**INTERIM REVIEW OF
US ARMY CORPS OF ENGINEERS
LOWER SKAGIT RIVER FLO-2D MODEL**

**NORTHWEST HYDRAULIC CONSULTANTS INC
20 DECEMBER 2007**

Skagit River Flo2D Model Review

Figure 1: Preliminary USGS Lidar DEM vs. COE Photogrammetric Spot Elevations

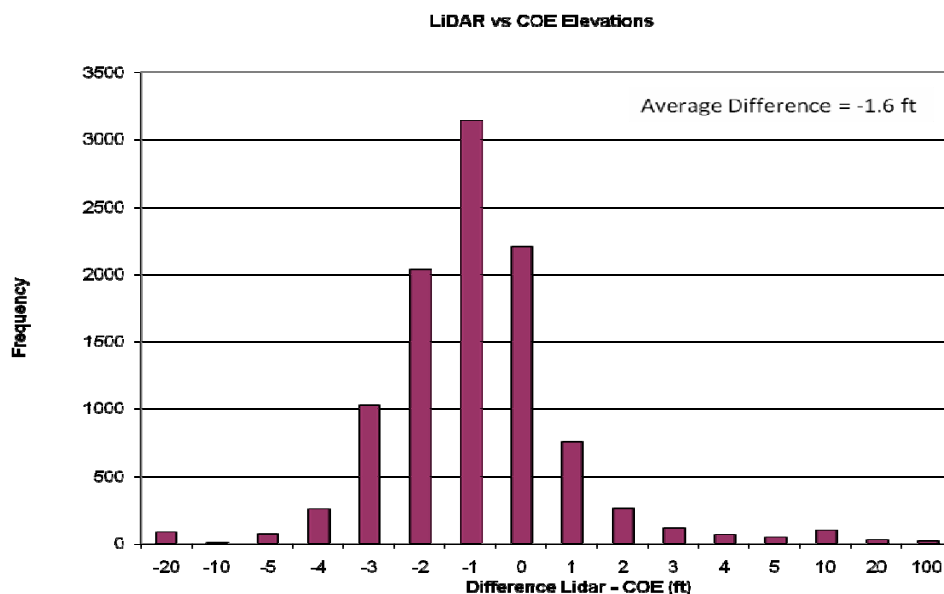
The lidar data averages 1.6 ft lower than the COE dataset for the 10,216 points we compared. There was no apparent geographic distribution to the differences, which are shown below.

For this review we did not consider elevation differences between the model and lidar of less than 2 feet to be significant. We conducted our review using the lidar and aerial survey data, but clearly further quality checks of the lidar data are warranted.

Figure 2: Left Bank Levee and Bank Elevation Profile

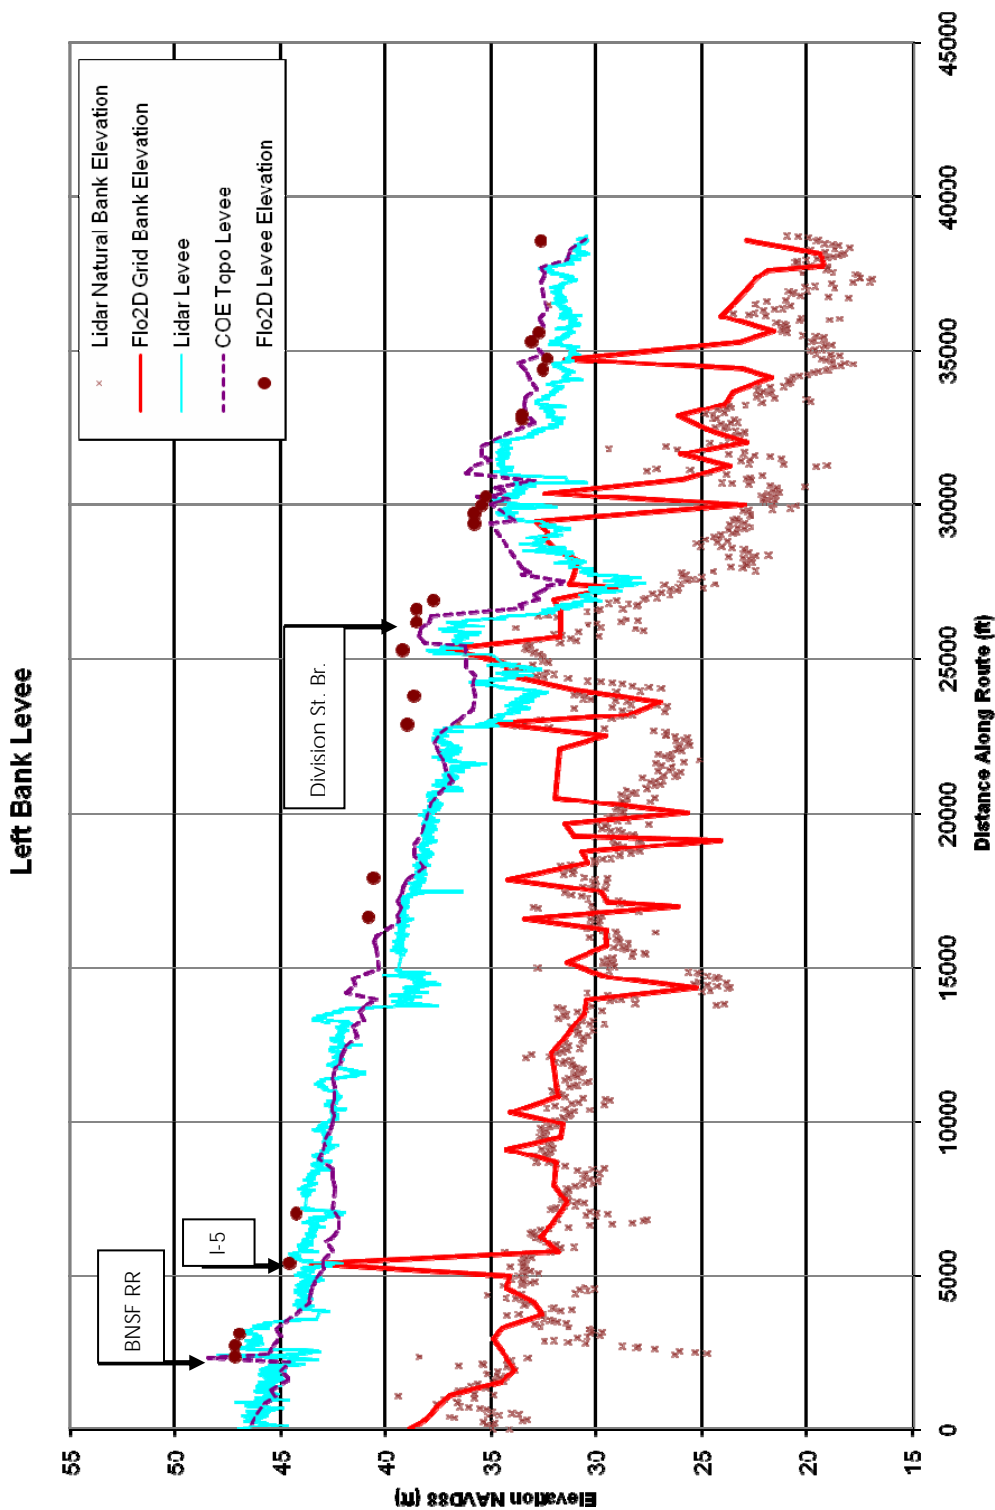
Bank elevations in the Flo-2D model generally agreed with the lidar data in the upper portions of both levees. Further down the river there are numerous locations where the modeled bank elevations appear to vary between the natural bank elevations and the

levee crest elevations. The modeled levee crest elevations vary from good agreement with the lidar data to up to 3 feet above it. Also plotted are the levee crest elevations from the Corps topographic survey.

The consequences of inaccurate bank and/or levee crest elevations are complex and may include both under and over predicting water surface elevations. Where the model has bank elevations that are erroneously set at the levee elevations, removing the levee to follow the FEMA policy will have no effect. In locations where the levee profiles are too high, the volume of overbank flow from levee overtopping will be underestimated. This could cause higher flood levels on the opposite overbank under the FEMA levee removal policy simulations.

- Our review identified areas of bank, roadway and levee elevations that appear to be high based on the lidar data. If the lidar data are found to be accurate, then the model should be modified and rerun to investigate whether more accurate elevations significantly affect flood levels.

Figure 4: I-5 Roadway Profile and Water Surface Elevations

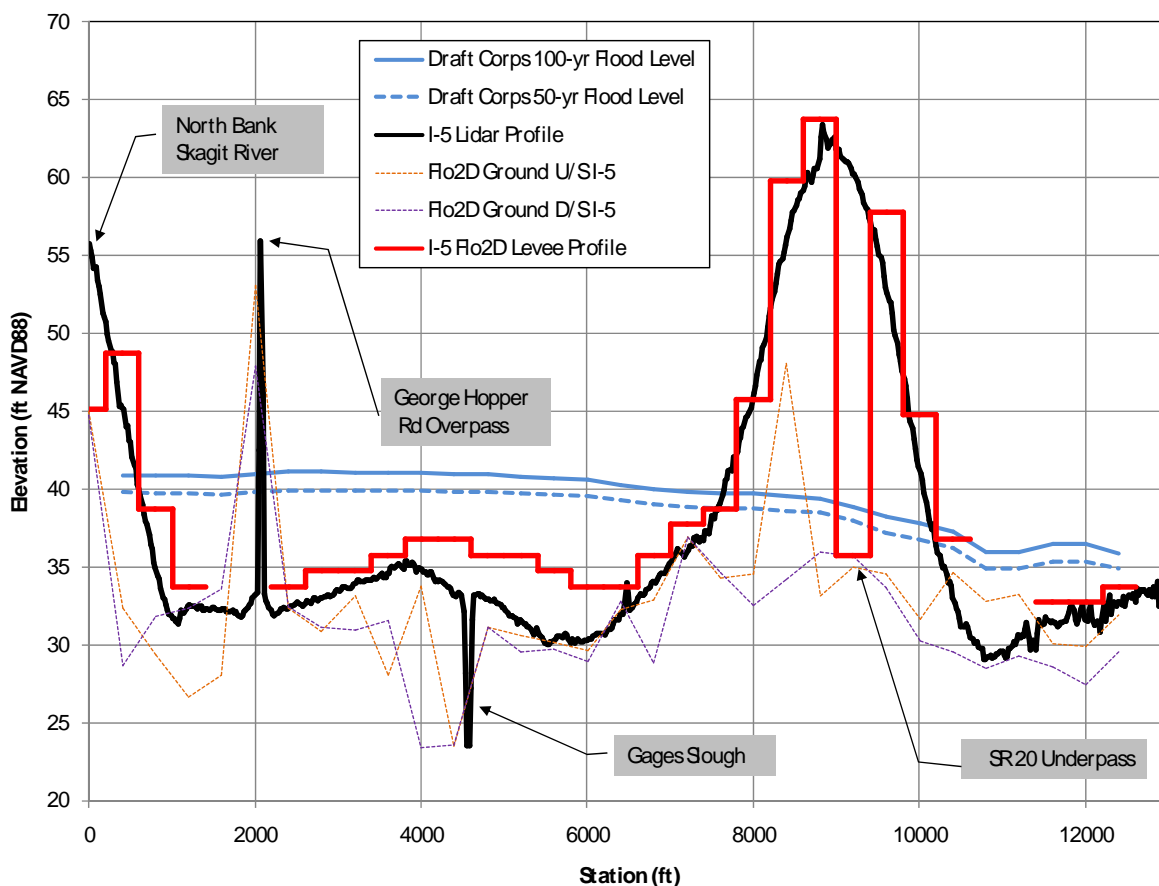
It appears that the model may not accurately represent the I-5 roadway crest elevations in the area beginning south of Gages Slough and extending north to where the roadway rises to cross over Highway 20. The lidar shows the roadway is 3-5 ft lower over nearly 3000 ft in this area. Weir flow increases exponentially with depth, so if the lidar is correct the model could be underestimating the flow capacity across I-5 by a

substantial margin, an important factor governing upstream water levels through the core of Burlington.

- WSDOT has been asked to determine if there is any high accuracy I-5 roadway elevation information available to help evaluate the preliminary lidar data.
